City of Portland, Maine – Building or Use Permit Application 389 Congress Street, 04101, Tel: (207) 874-8703, FAX: 874-8716

HAYMAN RESIDENCE
REED AVENUE
PEAKS ISLAND, MAINE

BUILDING PERMIT REPORT

RE: Rail System at Hayman Residence on Peaks Island

Ele.: [Signature]

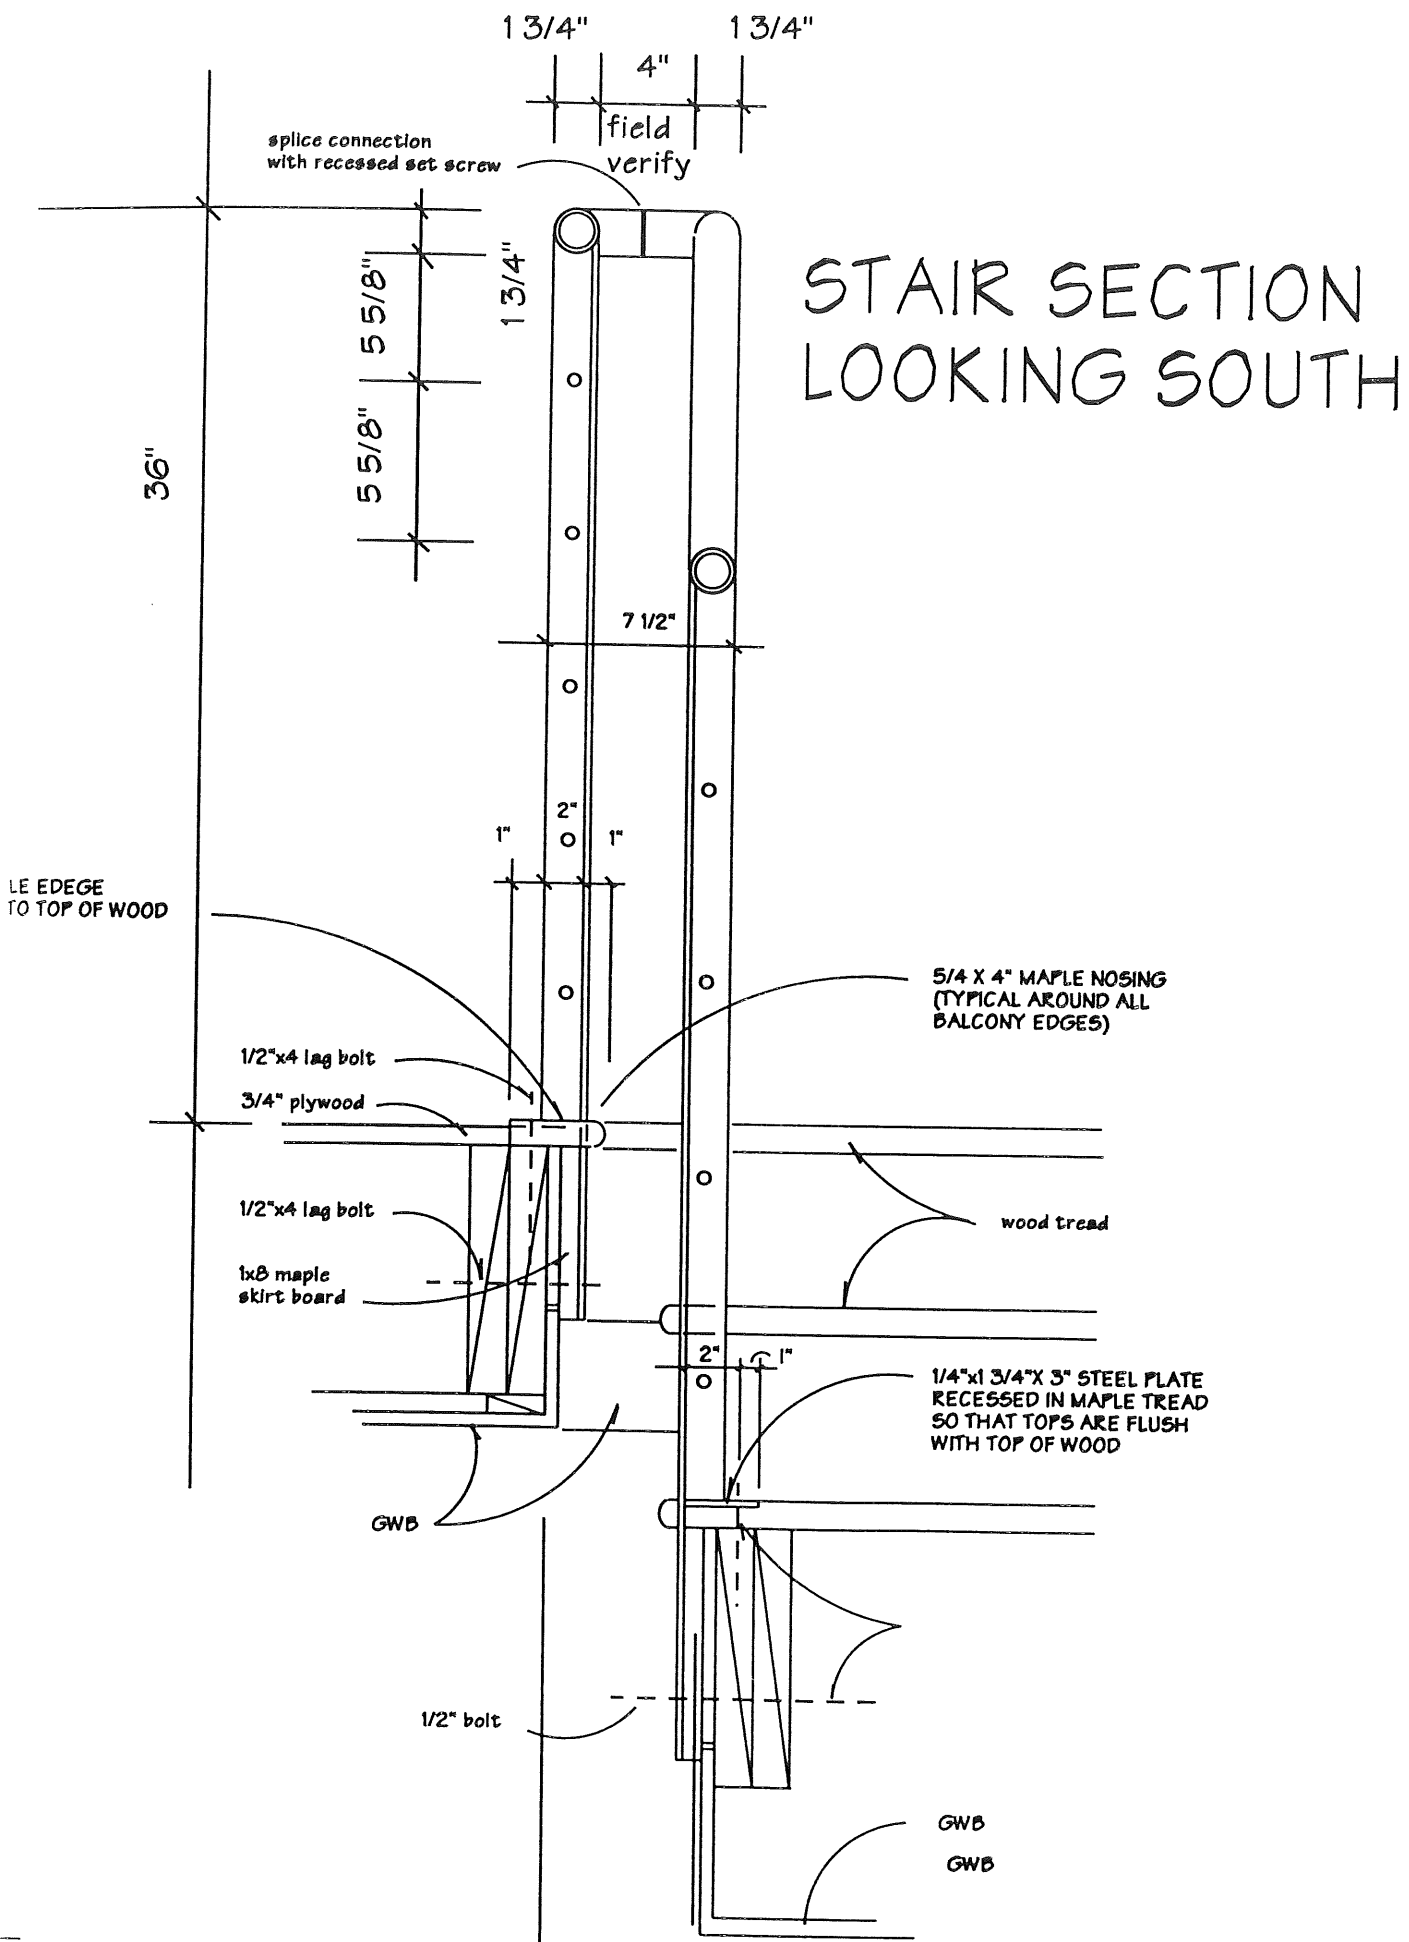
Liberties were taken during the design, that makes the hand rails and gard rails non-compliant with the 1996 BOca code. Sec 1021.3, BUT the rails do not effect the stair system structure, or its Fire performance. Therefor, with the understanding, if the stair rail system is redone it will meet present code standards.

Please find enclosed drawings from which the rail system at the Hayman Residence was constructed. As discussed with you and our clients, the architect is aware that liberties were taken during the design that technically make the rails non-compliant with the 1996 BOCA code.

I do however feel that the rails are extremely safe and will serve to protect vertical openings from mishaps by children of all ages as well as adults. The rails are extremely rugged and easily grasped. We feel the close spacing of the horizontals meets the spirit of the code. Given that this project is a private, single family home, the client and architect hereby formally request a waiver of the strict interpretation of the code and further request that a certificate of occupancy be issued.

I have reviewed, this plus seen the job well after completion. This work did not or does not meet the letter of the code as per section 1021.3, but the handrails does not affect the stair system structural or on its fire performance. Therefore, with the understanding as set forth and if the stair rail system is redone it will meet present code standards.
